{ Denotes changes to ADD. 98 - 10/15/76 CO ADD. 98 - 5/5/77

H-1 VIADUCT (WB)

INDEX TO DRAWINGS
ESTIMATED QUANTITIES

KEEHI INTERCHANGE
F.A.I. PROJ. NO. I-HI-1 (130): 17

{ } Denotes changes to C.O. 101 - 5/5/77.

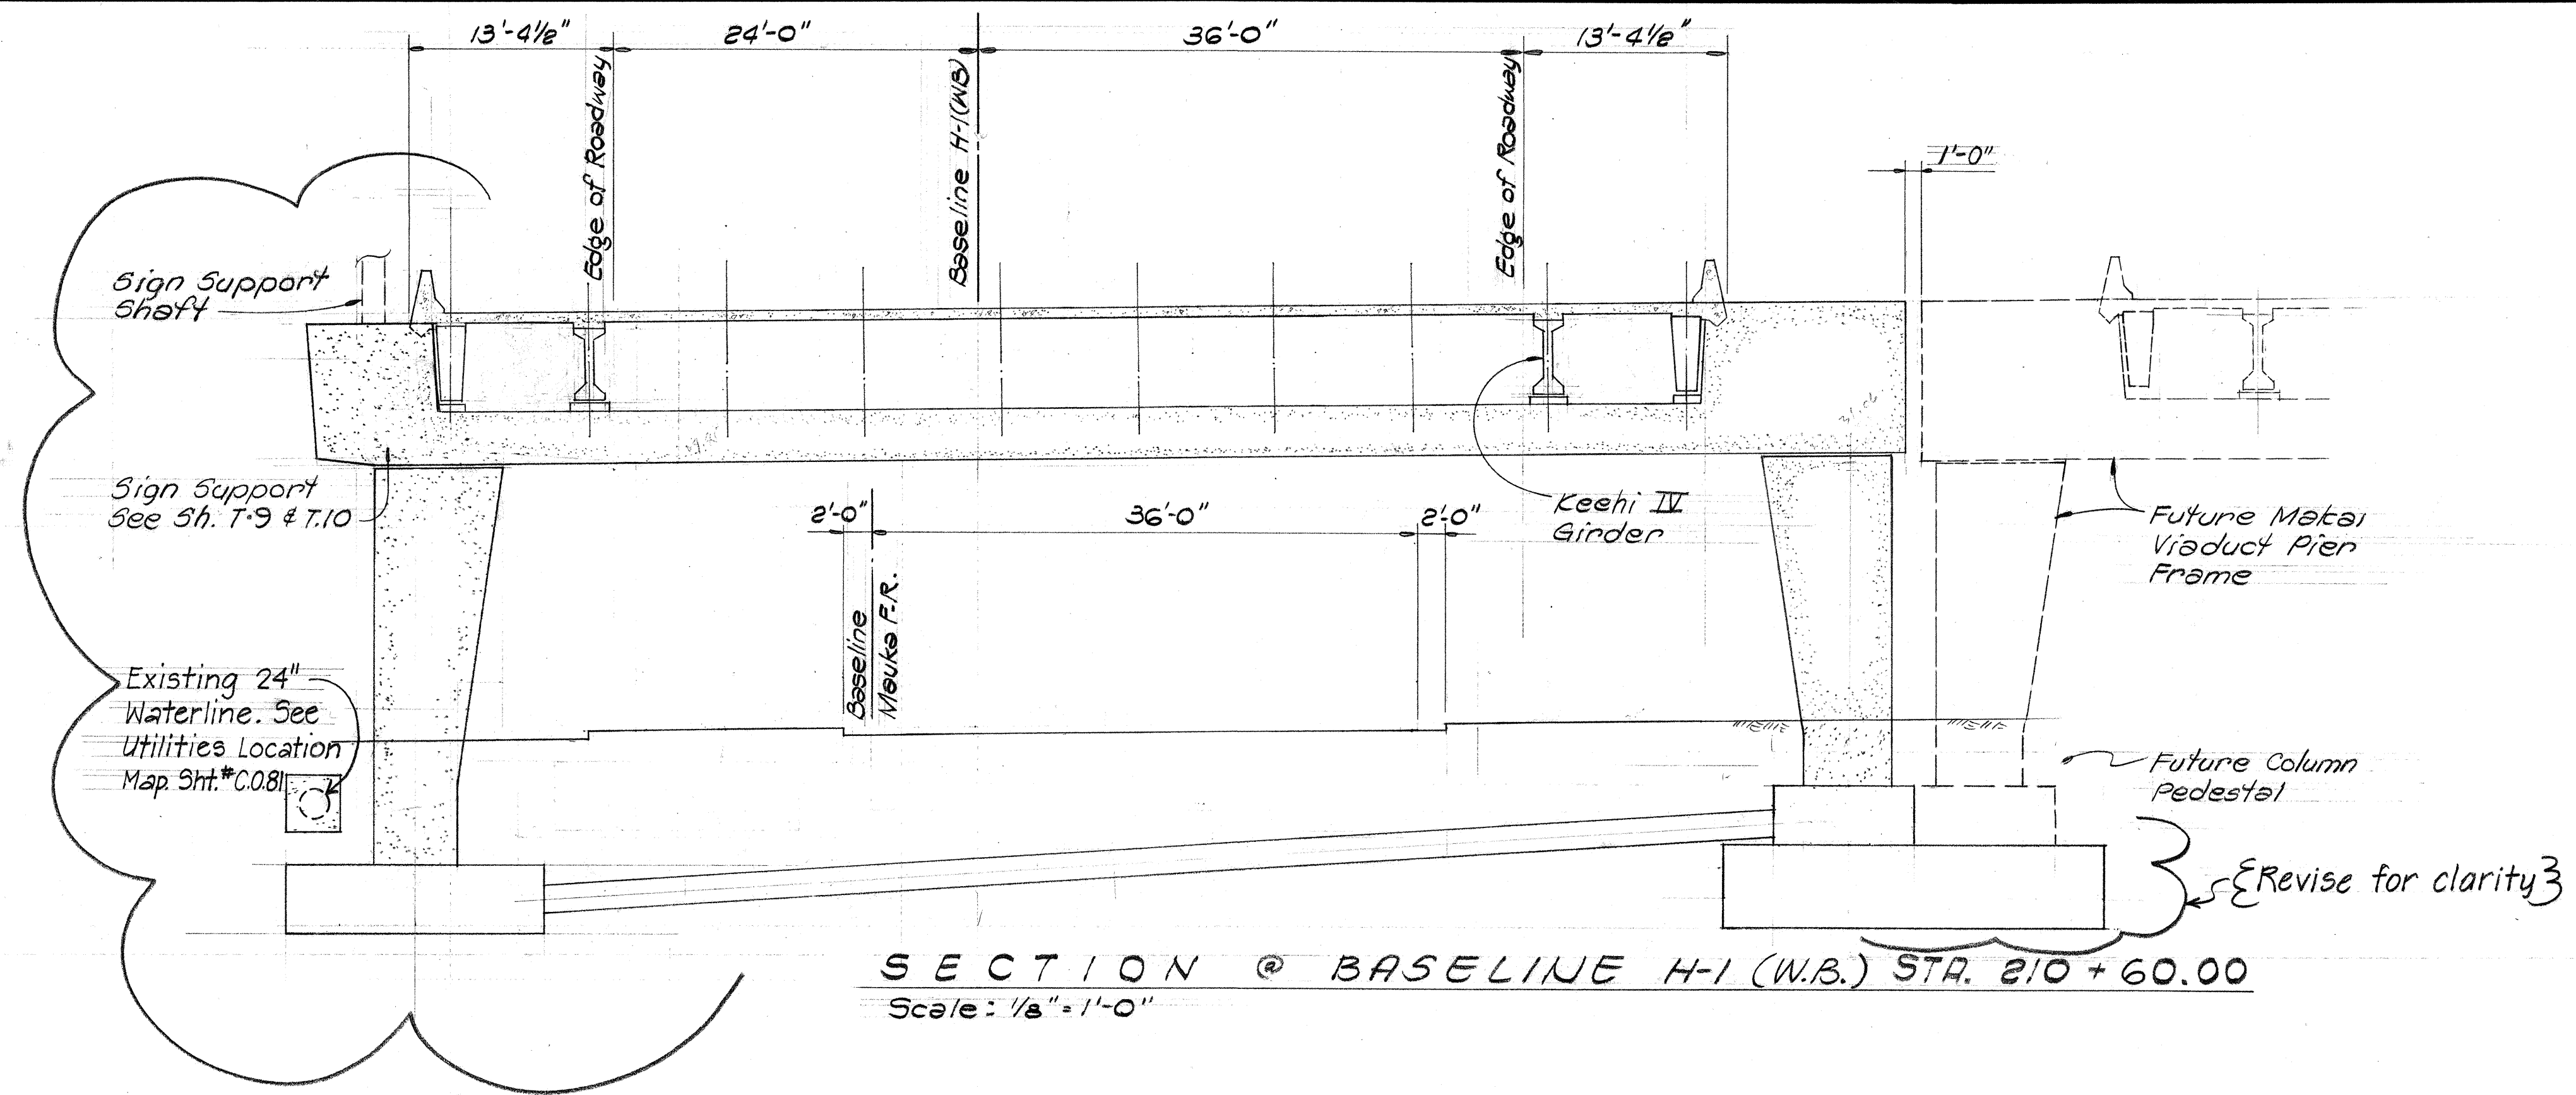
5/5/77	Revise section Sta. 210+60.00 Pier No. 1 elevation in parts and revised foundation for clarity.
DATE	REVISION
STATE OF HAWAII DEPARTMENT OF TRANSPORTATION HIGHWAYS DIVISION	
H-1 VIADUCT (WB)	
TYPICAL SECTIONS & DETAIL AT EXISTING PIER	
KEEHI INTERCHANGE F.A.I. PROJ. NO. I-H-1(130):17	
Scale: As Shown	Date: Aug. 16, 1976
SHEET NO. 3-4 OF 22 SHEETS

TOP COLUMN KEY DETAIL

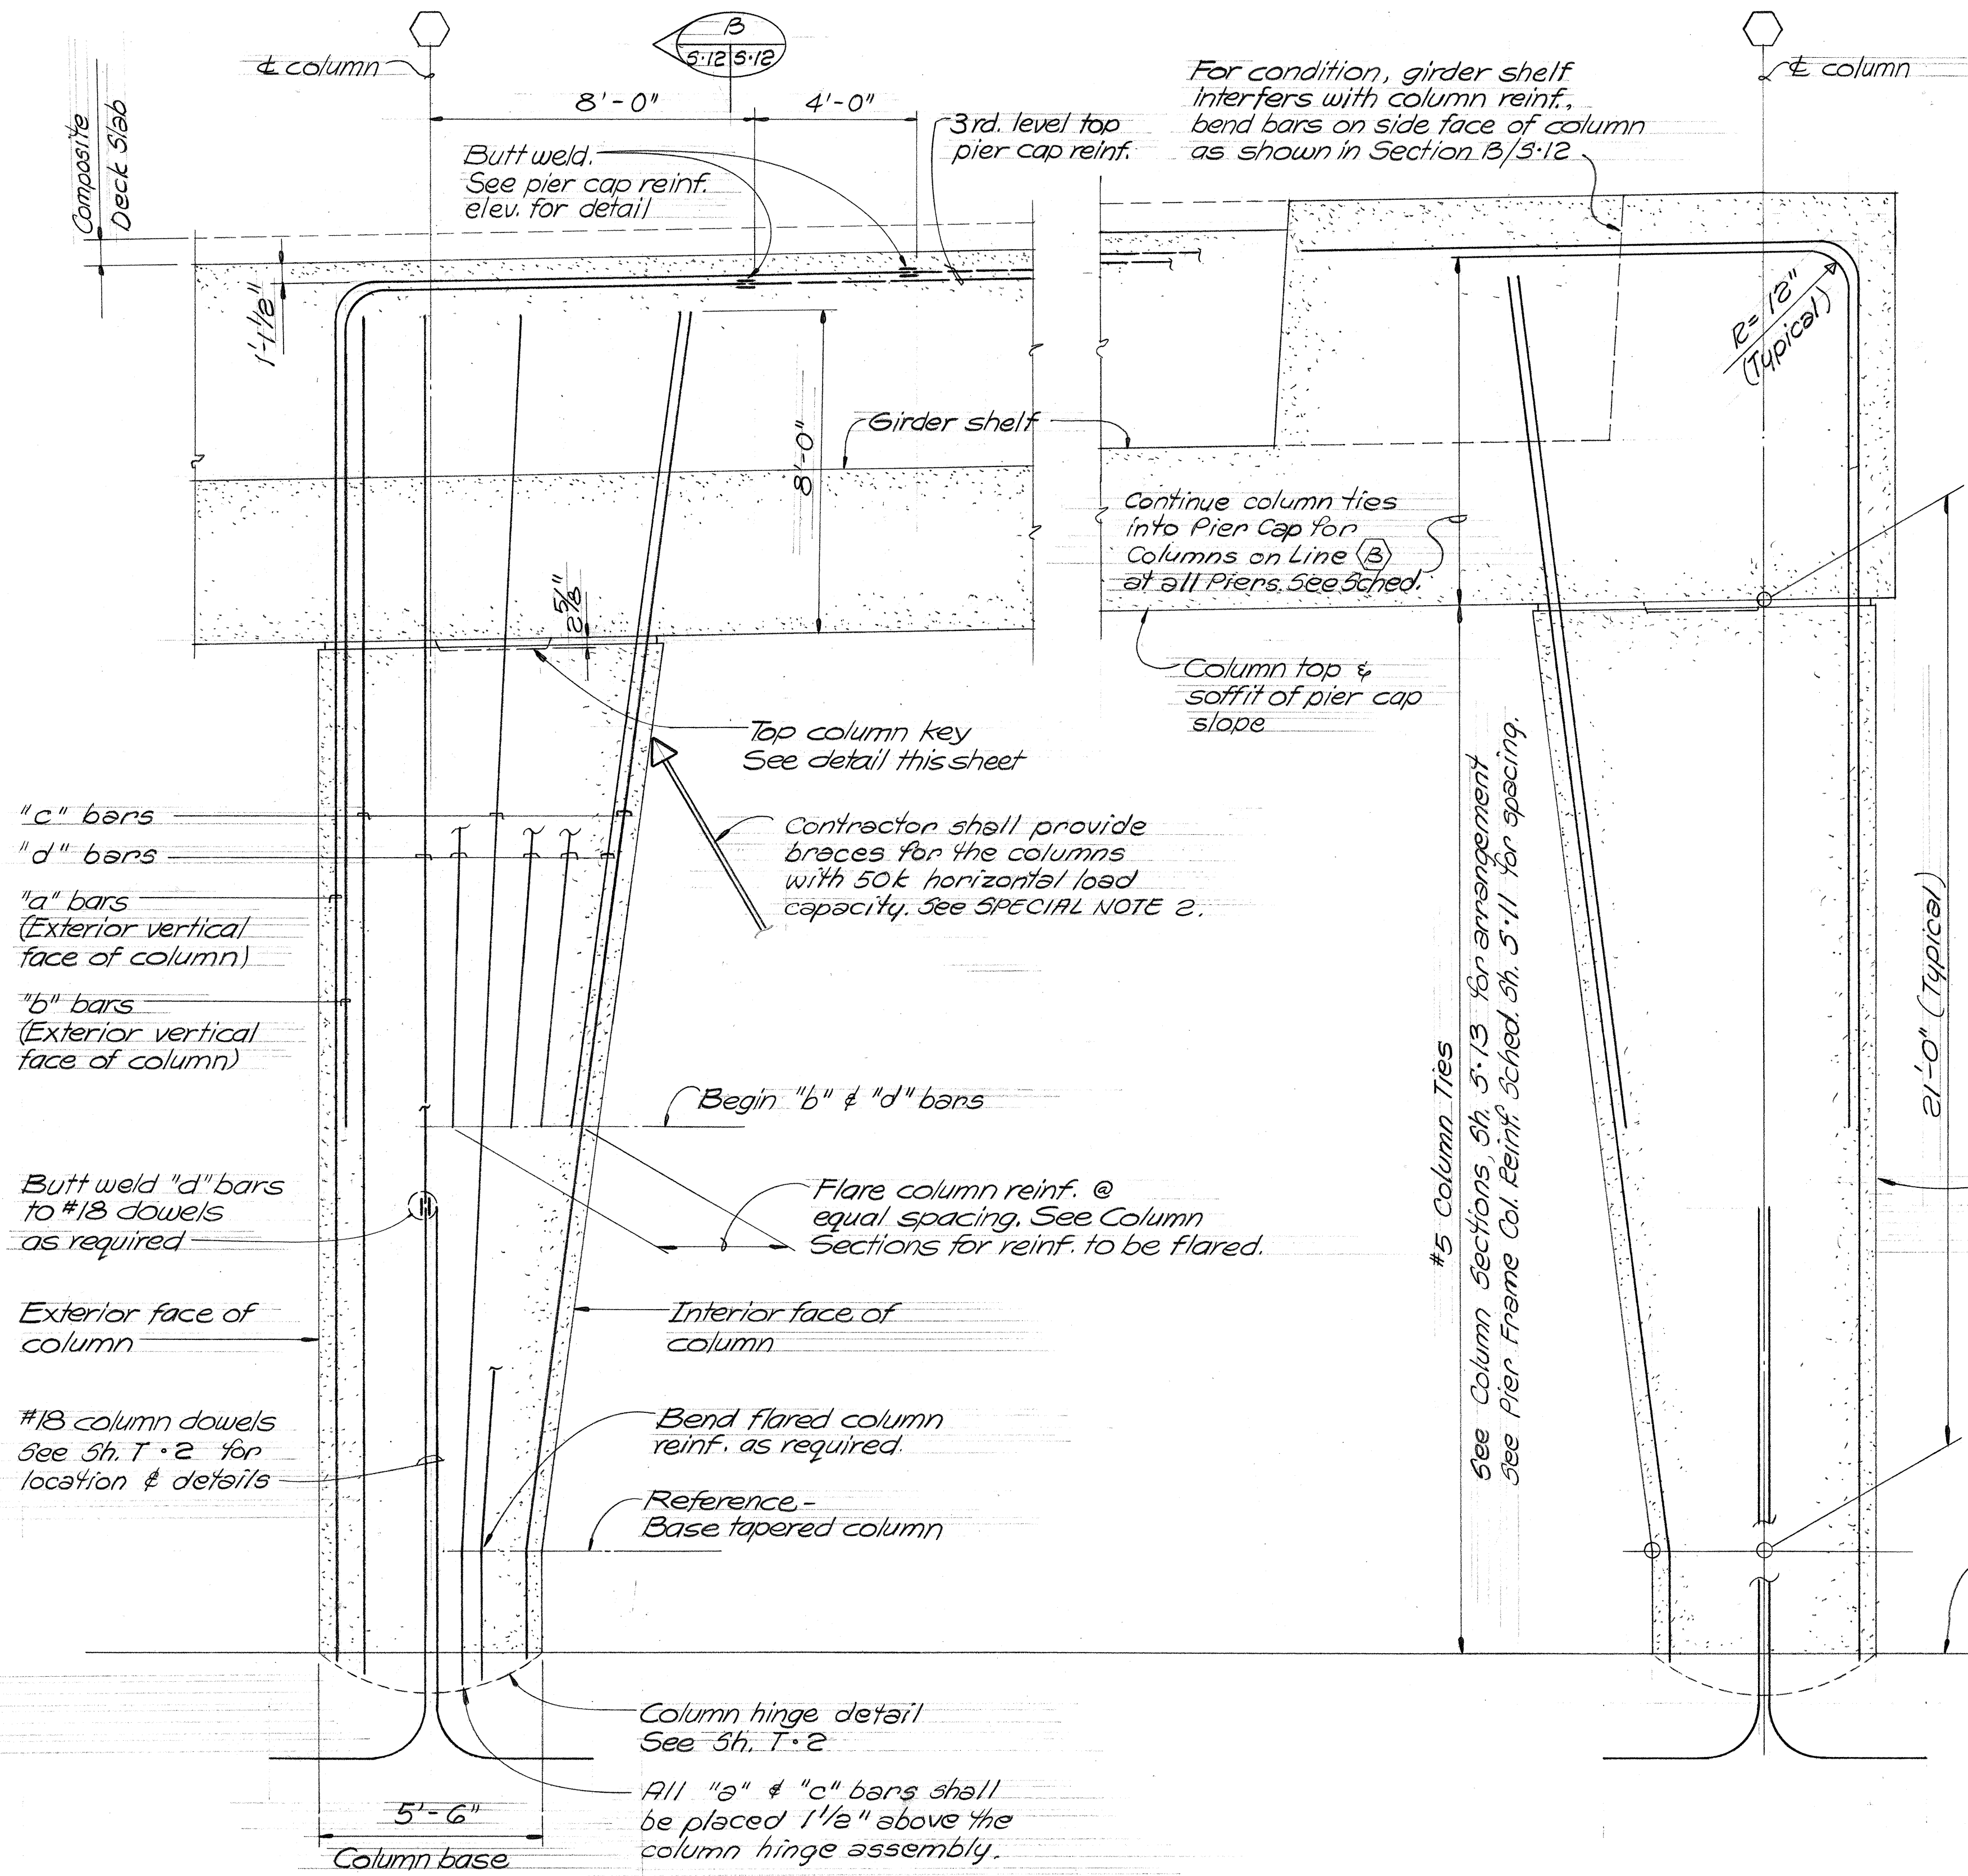
5/5/77	Modified column reinforcing placement & arrangement at Column Nos. (1-A), (1-B)
DATE	REVISION
STATE OF HAWAII DEPARTMENT OF TRANSPORTATION HIGHWAYS DIVISION H-1 VIADUCT (WB) COLUMN REINFORCING DETAILS	
KEEHI INTERCHANGE F.A.I. PROJ. NO. I-HI-1(130):17	
Scale: As Shown	Date: Aug. 16, 1976
SHEET NO. 5:12 OF 22 SHEETS

PIER NO. 1 (TYPE I PIER)

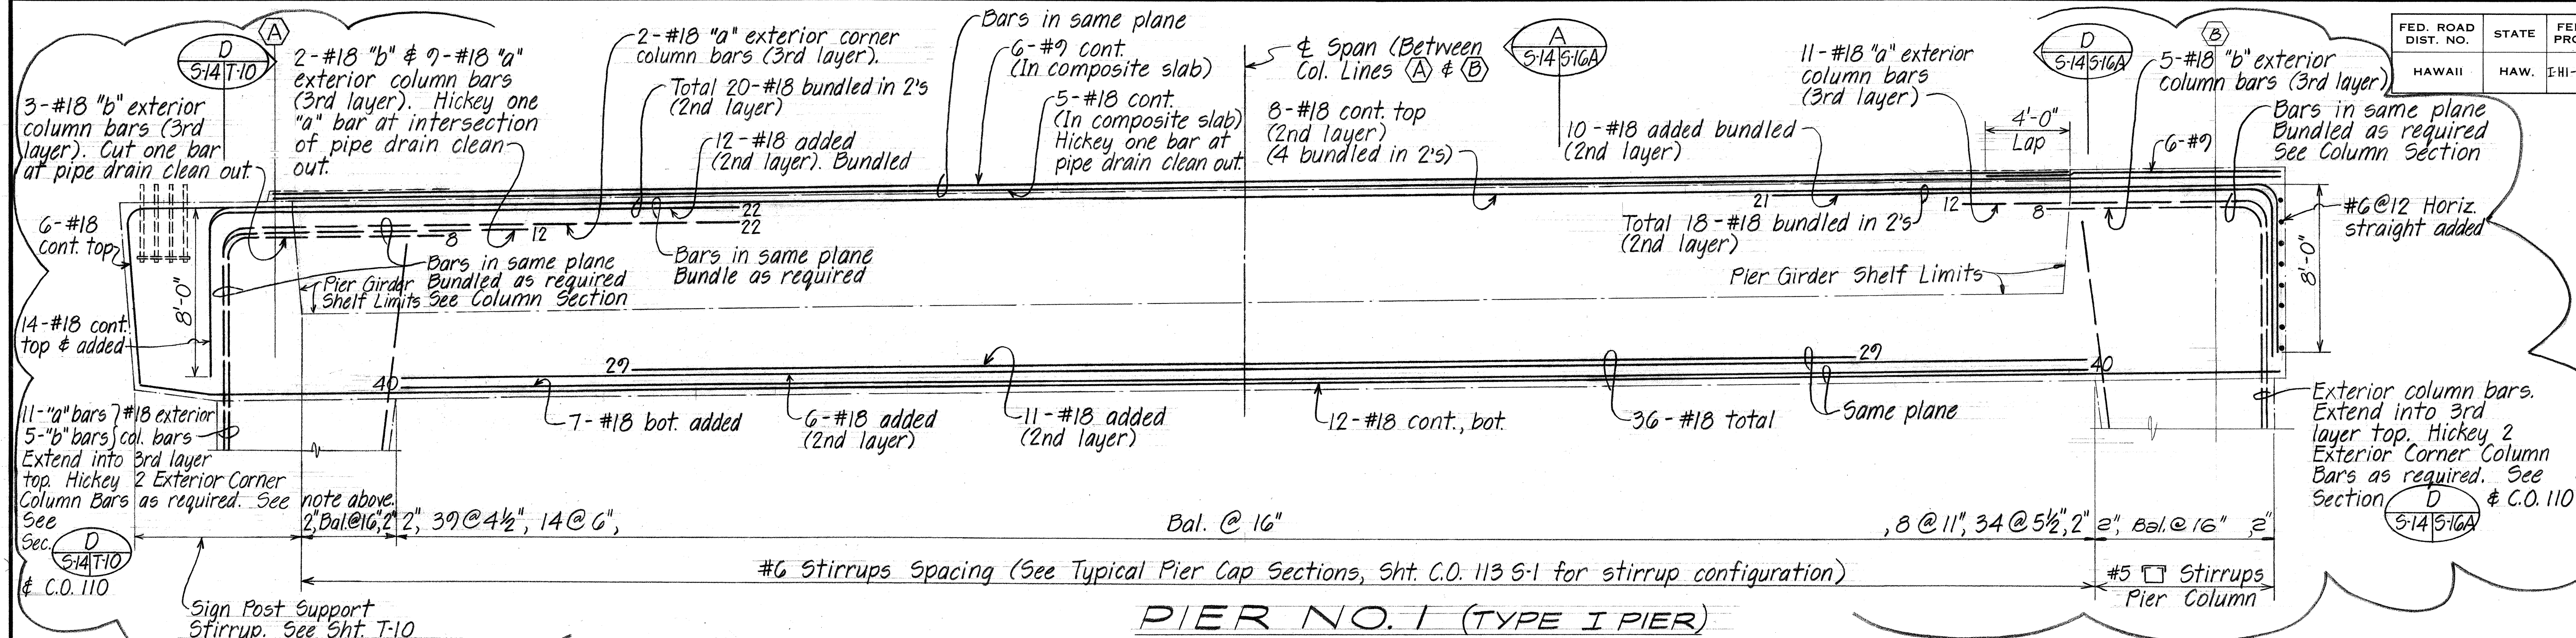
5/5/77	Revised Pier No. ① details and reinforcements.
DATE	REVISION
STATE OF HAWAII DEPARTMENT OF TRANSPORTATION HIGHWAYS DIVISION H-1 VIADUCT (WB) PIER CAP REINFORCING KEEHI INTERCHANGE F.A.I. PROJ. NO. I-HI-1(30):17 Scale: 1/4" = 1'-0" Date: Aug. 16, 1976 SHEET NO. 5-14 OF 22 SHEETS
